TSI 04/2020

Cylinder head gasket 867.700

Renault | Nissan | Mercedes-Benz | R9M | OM626

Changes to appearance

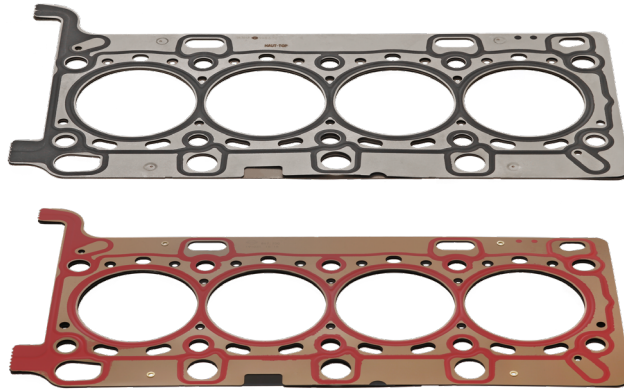
As part of the ongoing technical development of the cylinder head gasket 867.700, optimisations have been implemented at two points on the gasket. The colour of the seam coating has been changed from the previous black to red and provides increased temperature resistance.

In addition, the connection between the individual metal layers has been changed. The gasket with item number 598.670, which is no longer produced, was connected with four weld spots. On the successor gasket, item number 867.700, the metal layers are now permanently connected to each other with rivets. This does not essentially change anything in terms of the installation of the cylinder head gasket.

The type of connection has no influence on the gas and fluid impermeability functions of the cylinder head gasket.

Despite the significant changes, the original part number has been retained.
